Plugs, Pressure Protection Manifold CHU, CXU, GU, TD, PI, AN, GR, LR, MRU

FSB 563-008, Plugs, Pressure Protection Manifold

(March 2019)

W5145478

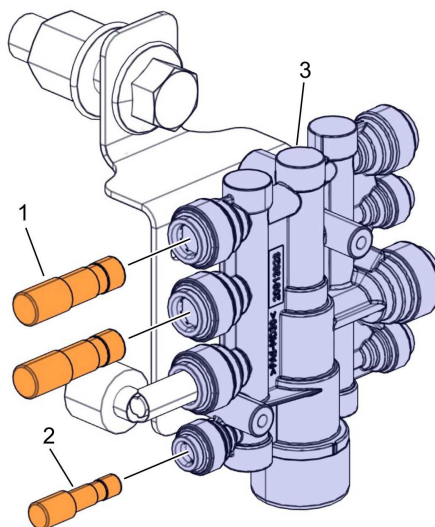
On certain trucks built from 02/17/2015, Mack Trucks has introduced new brass Pressure Protection Manifold (PPM) plugs part number 23480654, size 6.35 mm (.250 in) and part number 23480658, size 9.525 mm (.375 in) to be used **ONLY on Norgren PPM part Number 22650771**. The existing plugs (part number 25161826), size 6.35 mm (.250 in), and part number 25153853, size 9.525 mm (.375 in), both red in color are no longer used anywhere on the truck. The plugs (red in color) will be scrapped. The existing plugs (black in color) part number 8077186, size 6.35 mm (.250 in), and part number 8077187, size 9.525 mm (.375 in) are still used in the locations shown in the table on page 2.

Note: The black plugs **CANNOT** be used in the Pressure Protection Manifold (PPM) part number 22650771.
